STATE OF MAINE
DEPARTMENT OF TRANSPORTATION
☐ Approved
☐ Returned for Corrections
AUG 2[illegible] 1997
☒ Approved as noted
☐ Rejected

PROJ. NO. : BH-043-1(34)
ITEM NO. : 520.22

PROJECT: JOSHUA CHAMBERLAIN BRIDGE OVER THE PENOBSCOT RIVER, BANGOR-BREWER, ME

EXPANSION JOINT DETAIL @ PIER 1

DETAIL @ INNER BARRIER DAM

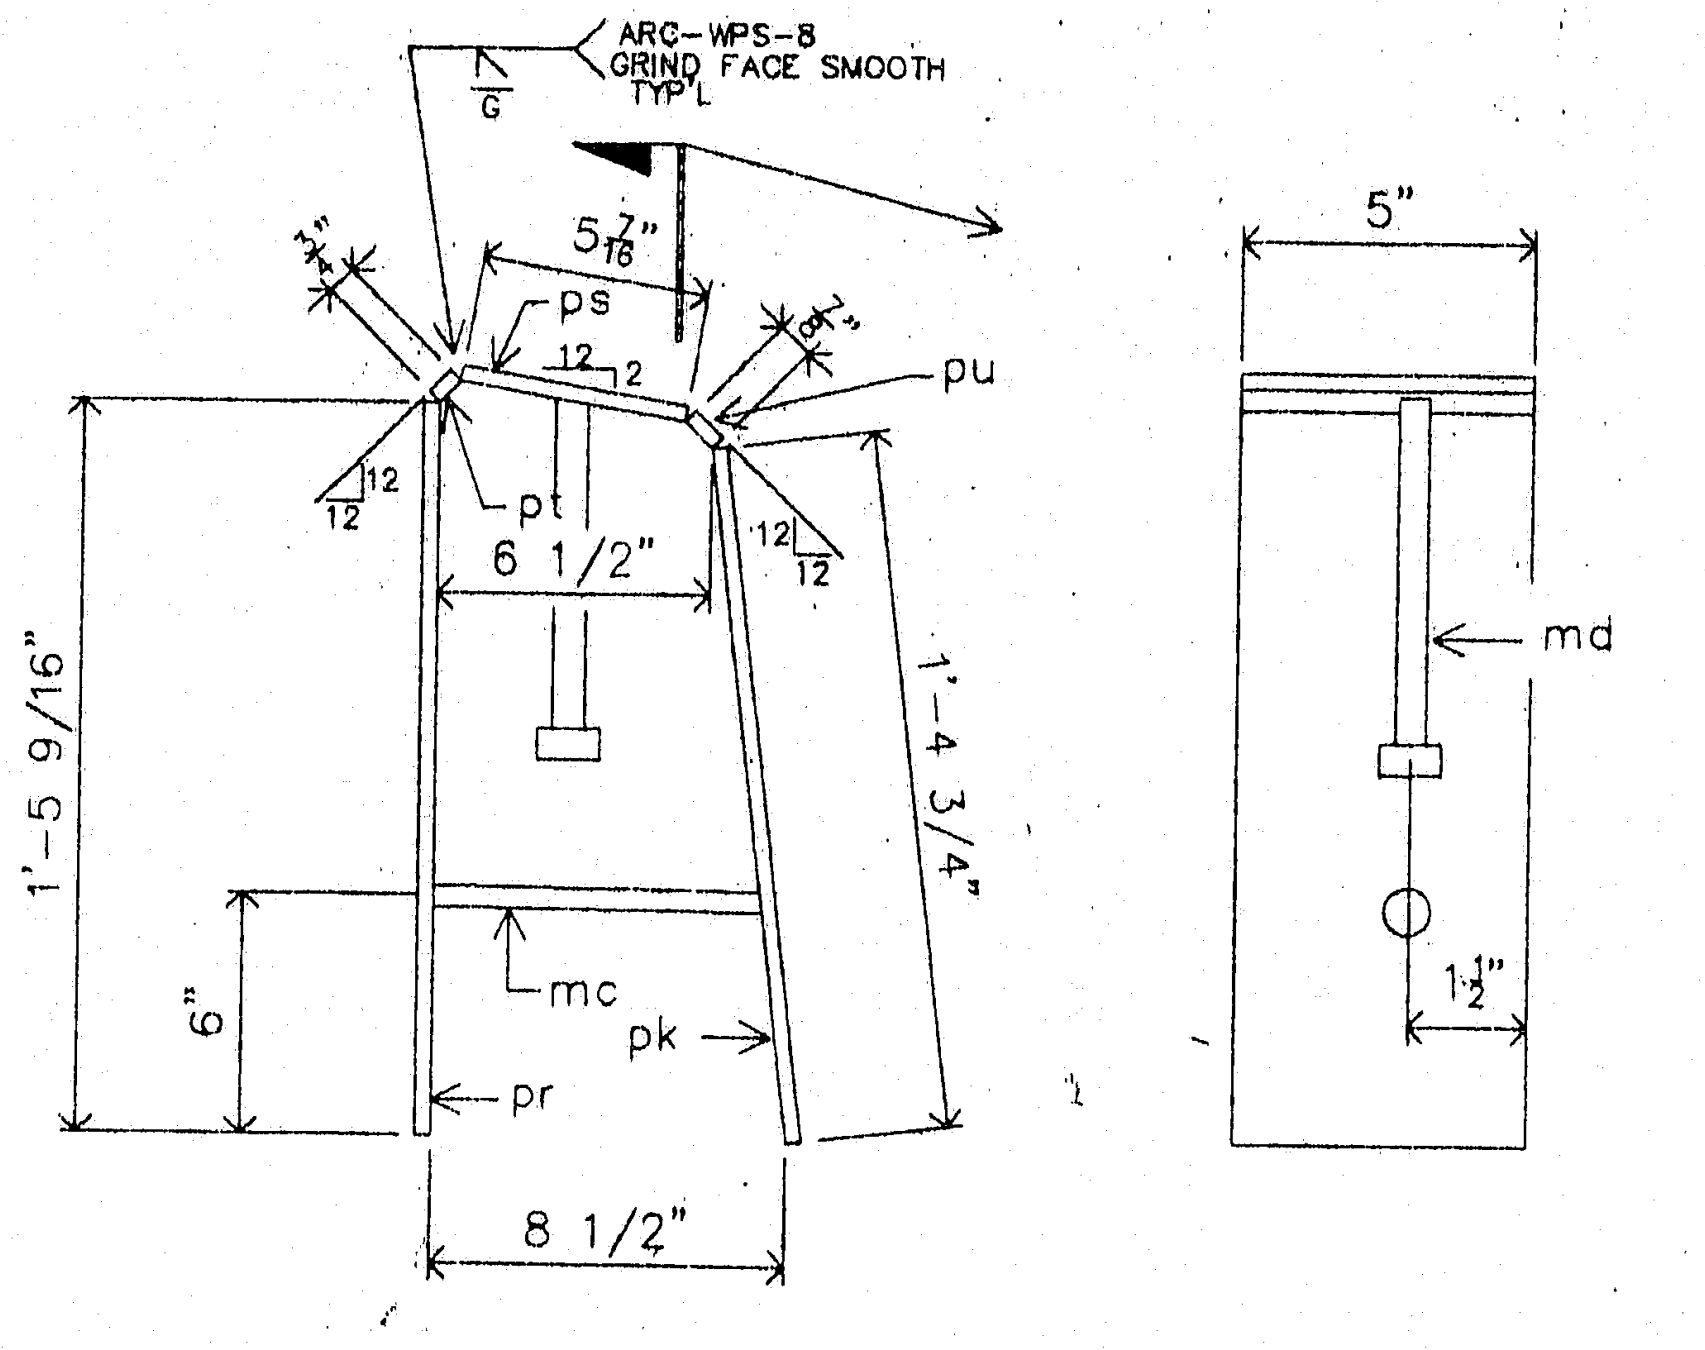
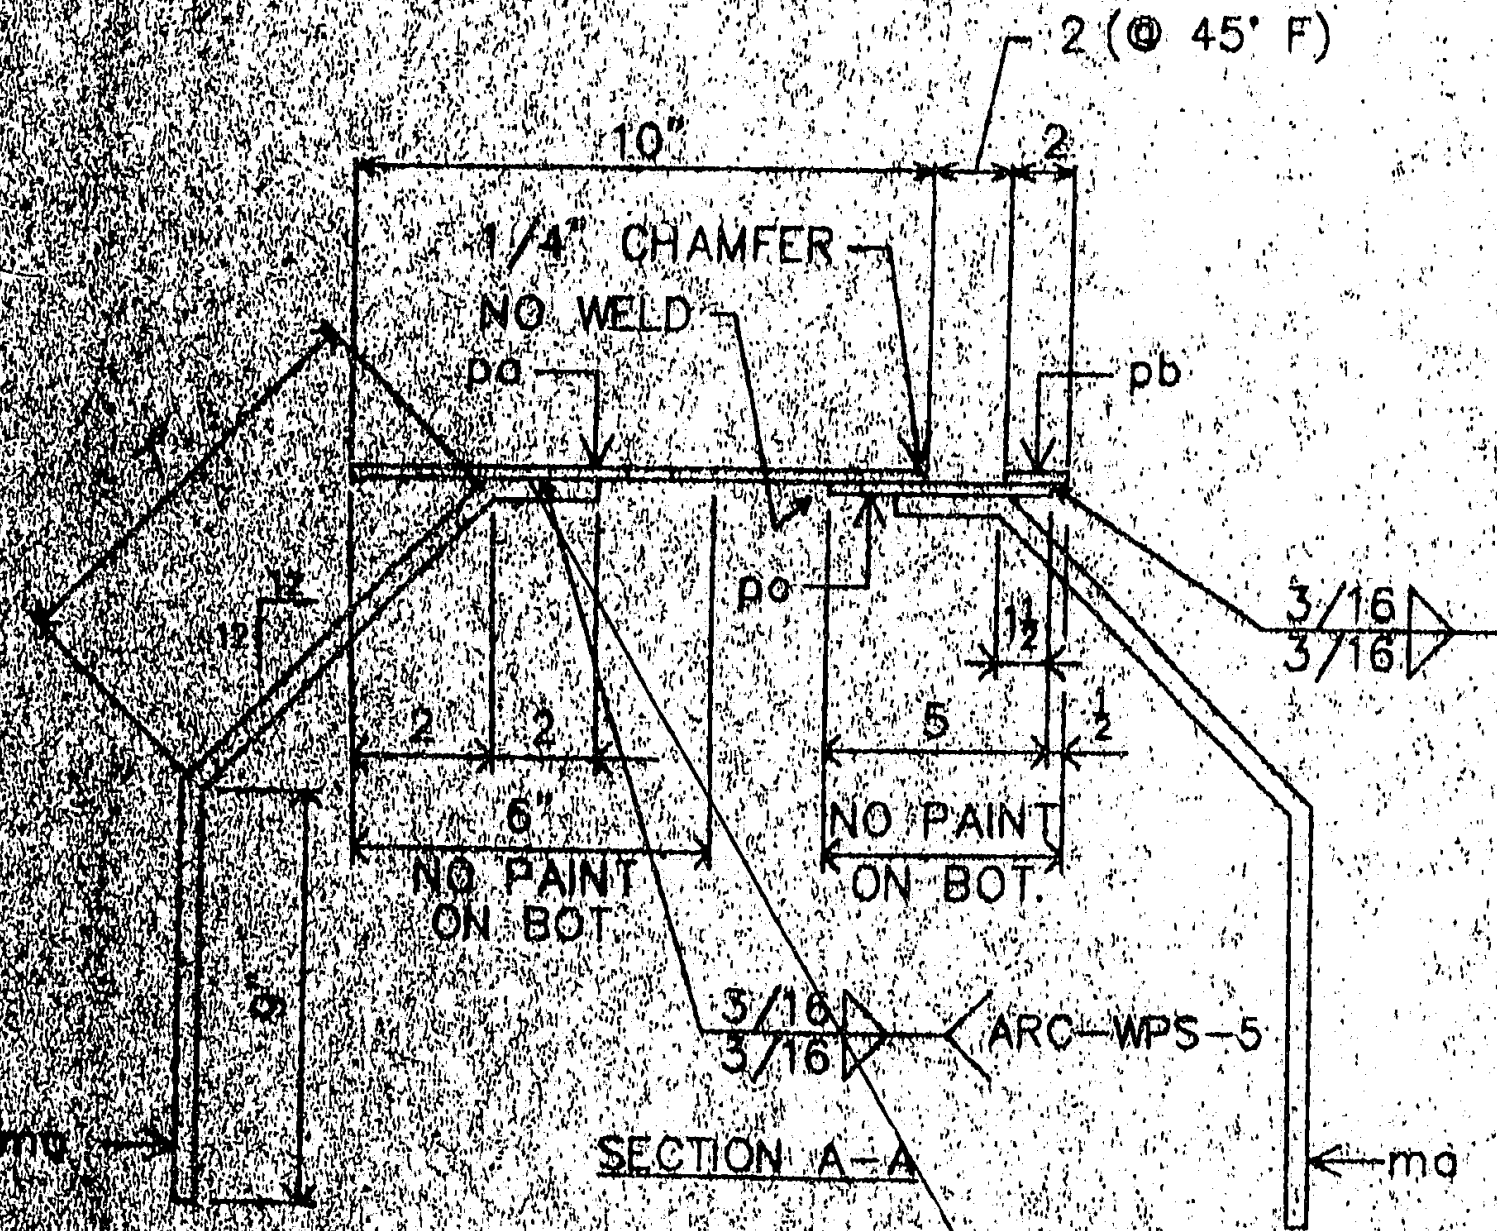
MATL: A36 UN HOLES: AS NOTED
WELD: PER PROCEDURES NOTED
PREP: SP6
FINISH: ~~3 COATS ZINC RICH PRIMER~~
~~3 MDFT PER COAT~~

* Prefer - Get Price on Galvanizing Assembly.

or
Use different Paint System.
Use NepCoat List;
Typical Systems:
Carboline
Wasser
Keeler & Long
Should Use
1) Zinc Rich Primer
2) 2 Part epoxy
3) Urethane.

DETAIL @ OUTER BAR STOP

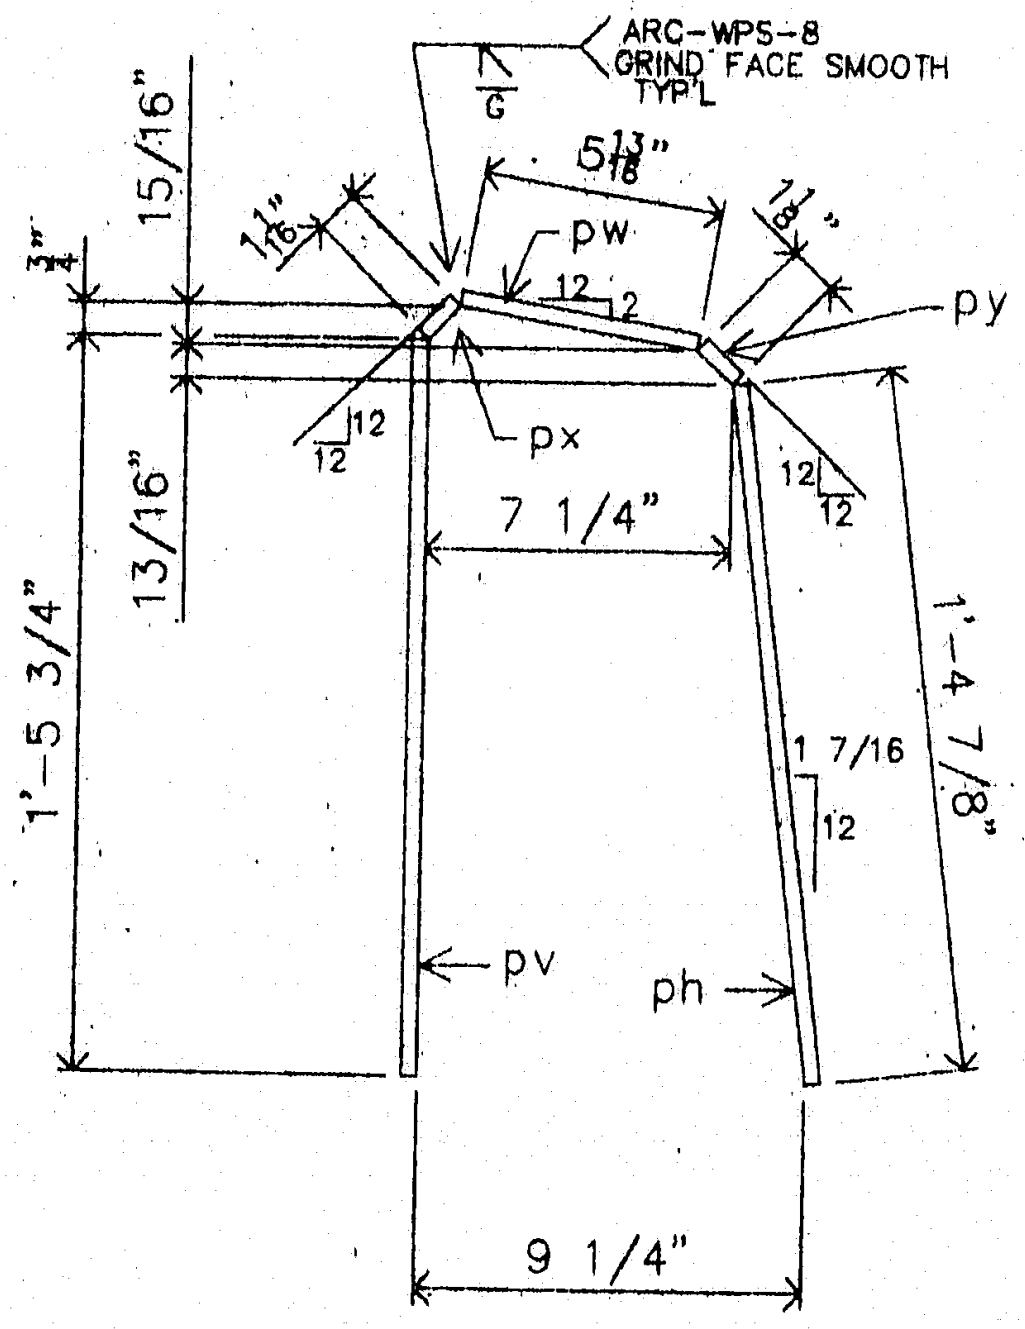
Submit WPS
For the weld
Including elevated
temperature Requirements
For Welding Reinforcing
Steel. i.e. AWS D1.4

(or) Substitute a Flat bar of
Appropriate size and
Strength and use an
existing Fillet weld Procedure.

ONE-EXPANSION JOINT-A4
(PLAN)

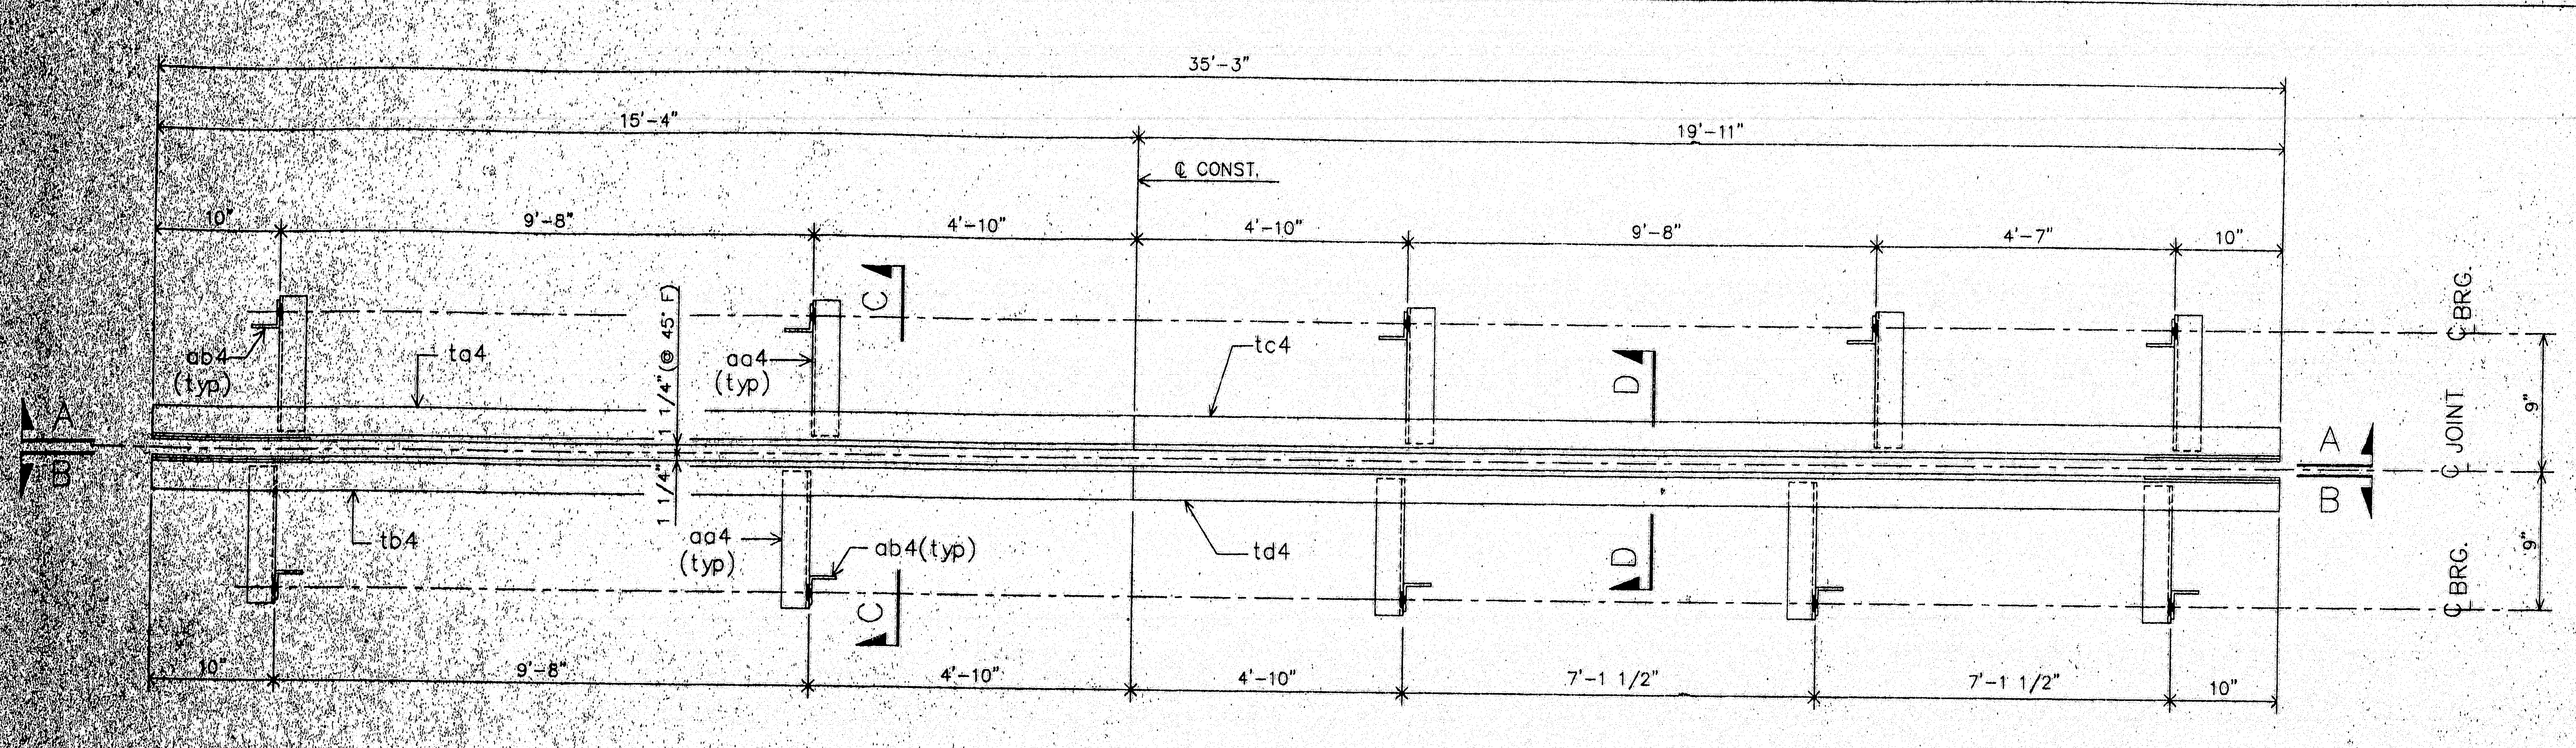
See Contract Dwgs, Note 9 on Sheet 2. Contractor will verify Dimension. (Typical)

MATL: A36, UN HOLES: AS NOTED
WELD: PER PROCEDURES NOTED
PREP: SP6
PAINT: 3 COATS - ZINC RICH PRIMER
3 MDFT PER COAT

2 Coats Ok.

SECTION A-A

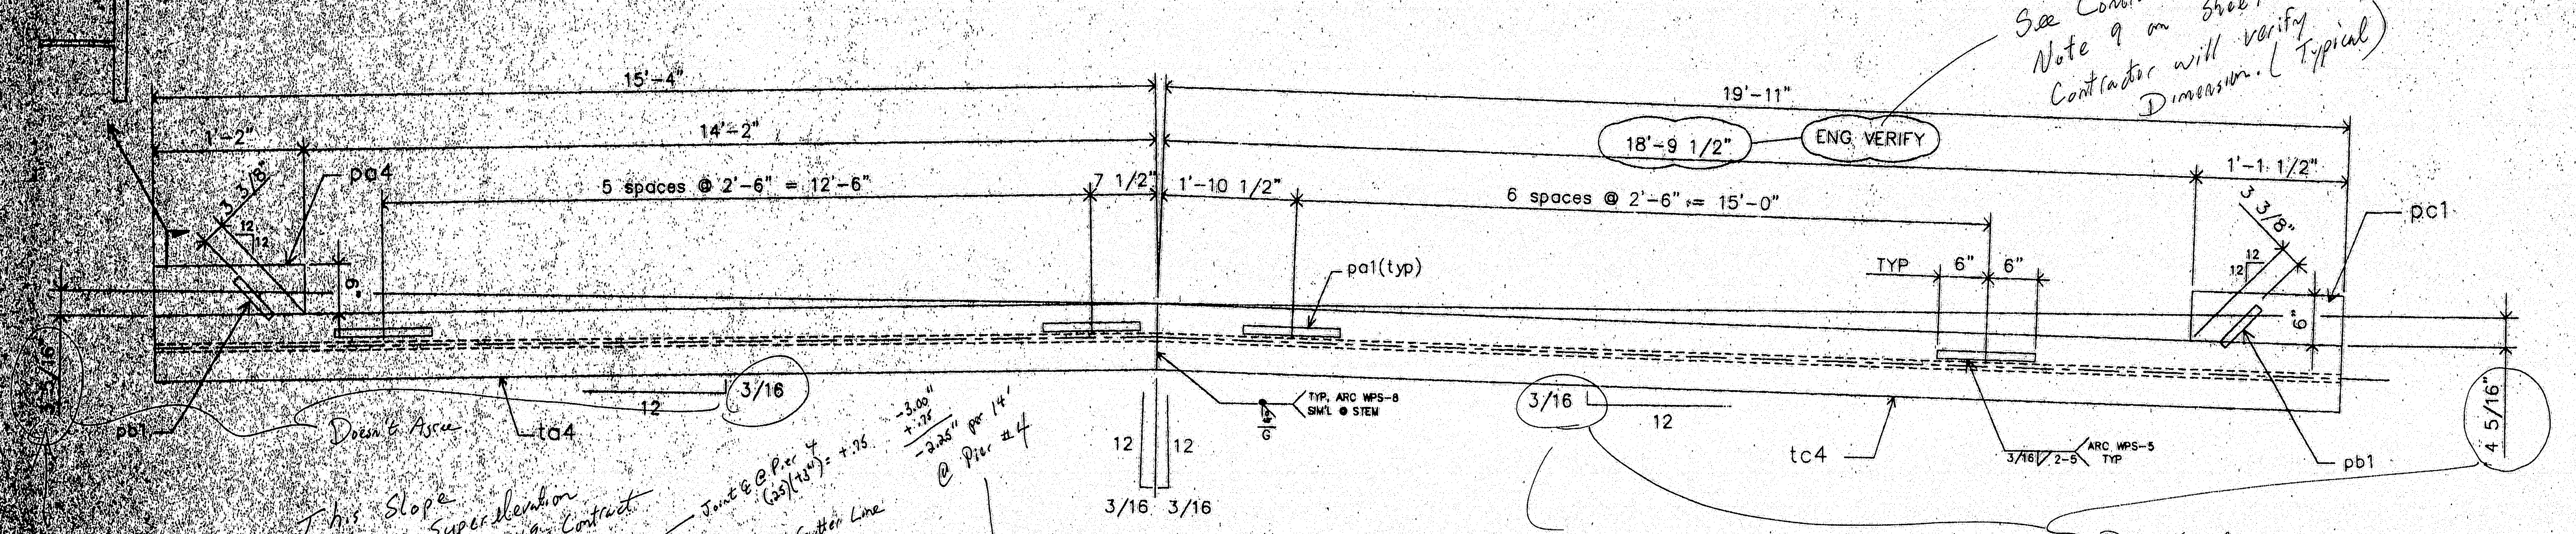
Doesn't Agree

This Slope Varies in Superelevation See Sheet 8 of 49, Contract Dwgs.

Joint ℄ @ Pier 4
(.25)(14.5) = 3.75

-3.00
+.75
-2.25" per 14' @ Pier #4

2.25" @ 0.160
14'

Doesn't Agree. See sheet 8 of 49 of Contract Dwgs.

3" in 14 feet is 0.214" ?

SECTION B-B

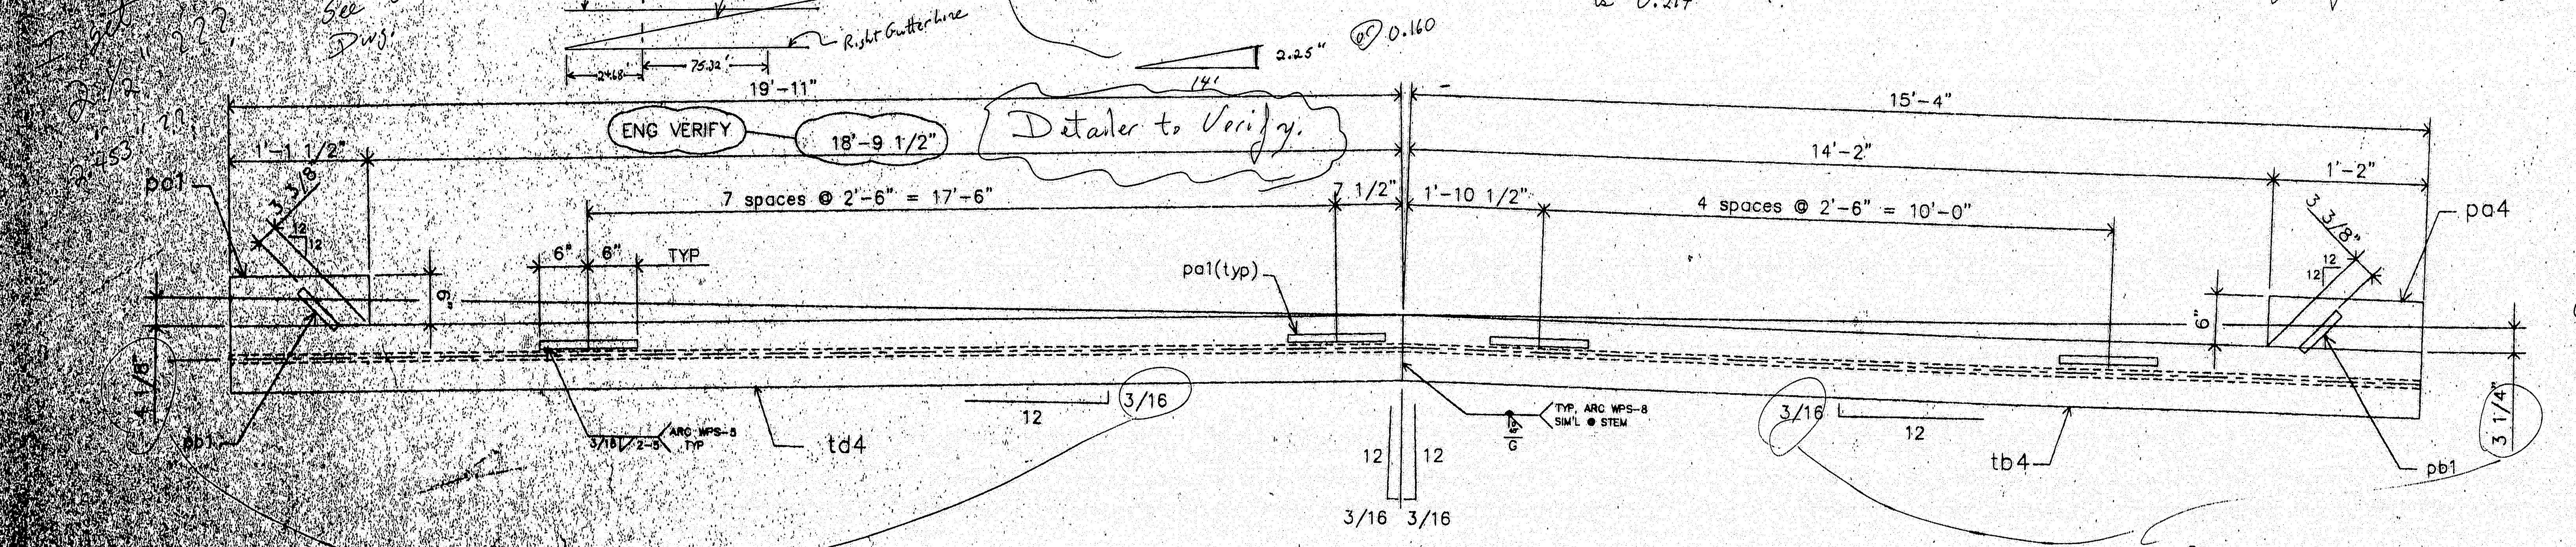
Detailer to Verify.
